CONSTRUCTION SERVICES FOR ENGINE HOUSE NO. 8 RENOVATIONS AND
UPGRADES

Solicitation Number: DCAM-19-CS-IFB-0012

Addendum No. 3

Item #1: Attachment J1 - Scope of Work/Drawings & Specifications for Engine House 8:
Attachment J1 - Scope of Work/Drawings & Specifications for Engine House 8 has been updated as per revision dated June 13, 2019 – See attached (**Exhibit 1**).

**FOOD SERVICE
EQUIPMENT
PLAN &
SCHEDULE**

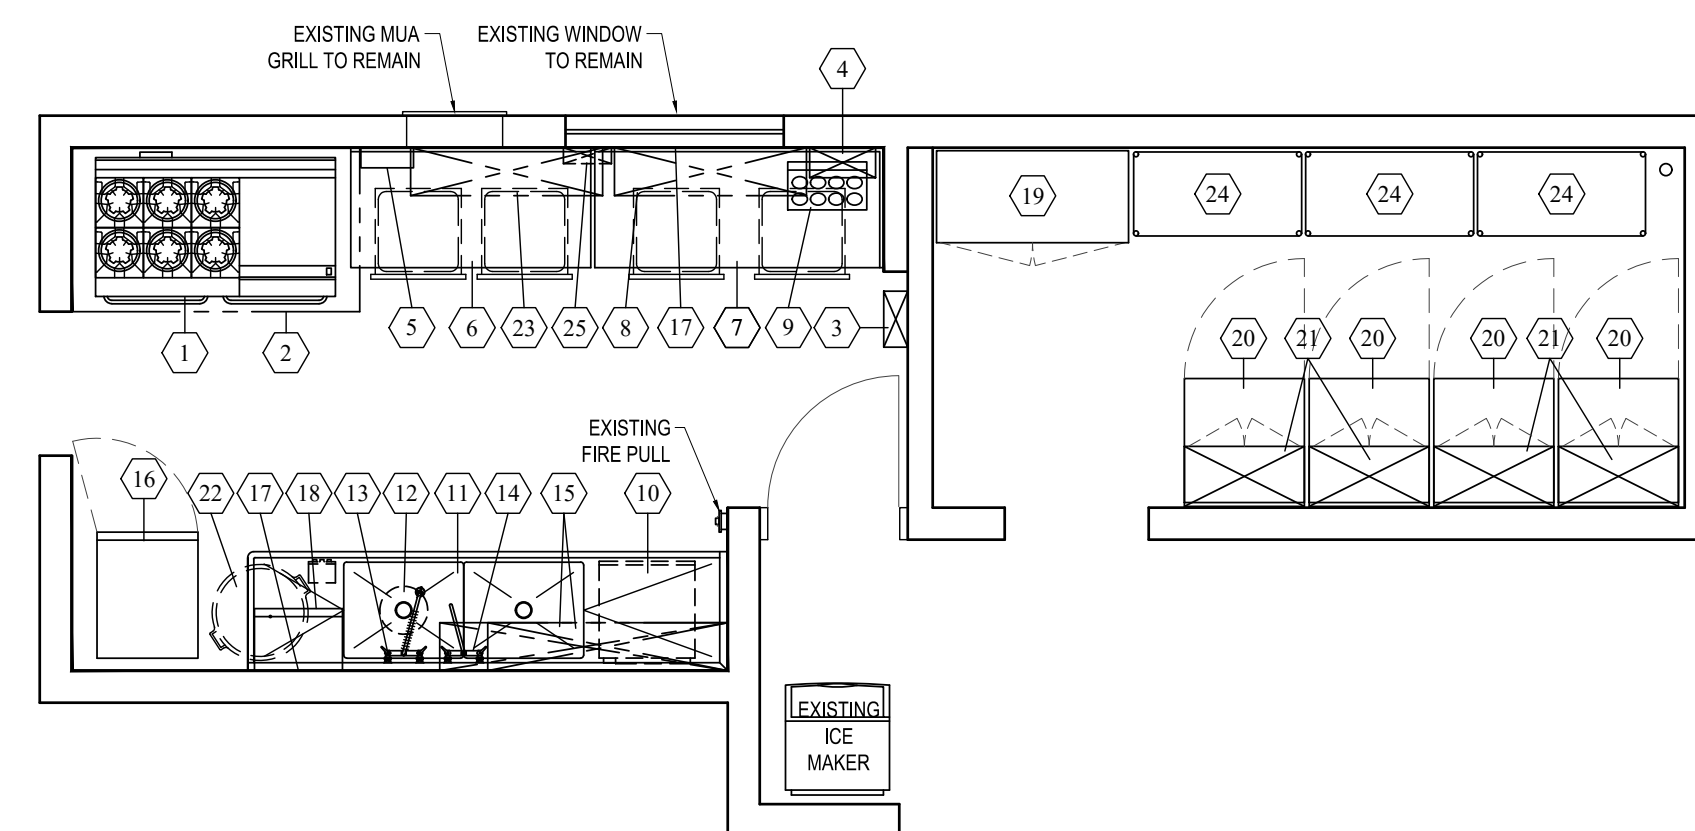
REVISIONS:	
06/13/2019	EXISTING WINDOW & MUA GRILL TO REMAIN. RELOCATE EXISTING ELECTRICAL PANEL, HOOD CONTROL PANEL & ANSUL CABINET

PLUMBING CONNECTION PLAN

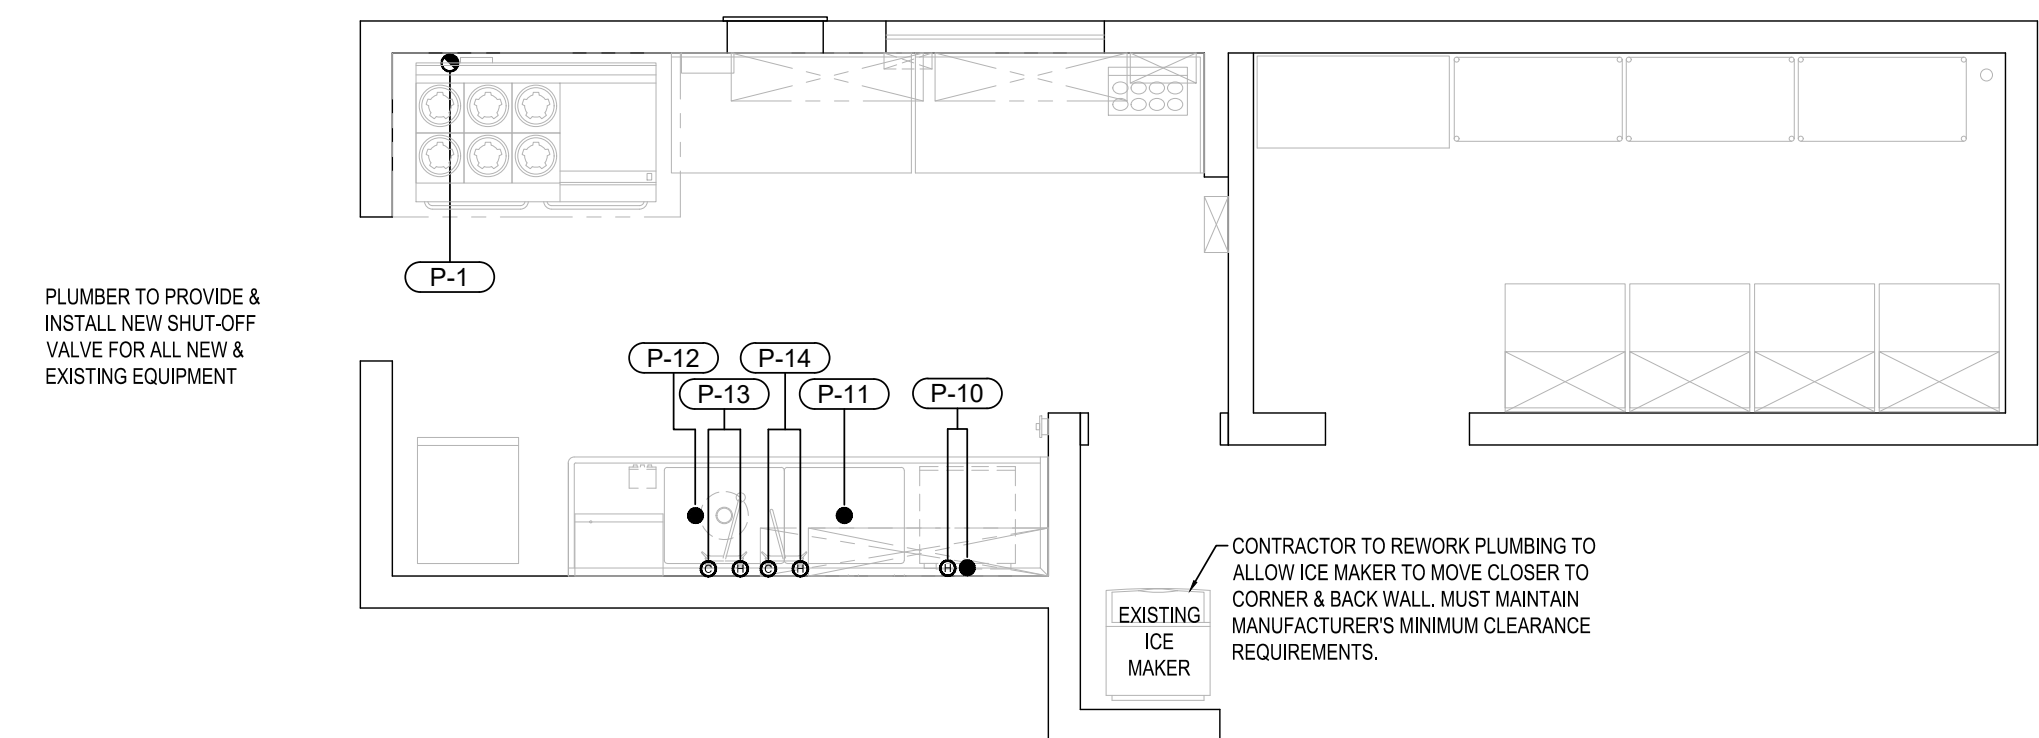
REVISIONS:	
06/13/2019	EXISTING WINDOW & MUA GRILL TO REMAIN. RELOCATE EXISTING ELECTRICAL PANEL, HOOD CONTROL PANEL & ANSUL CABINET
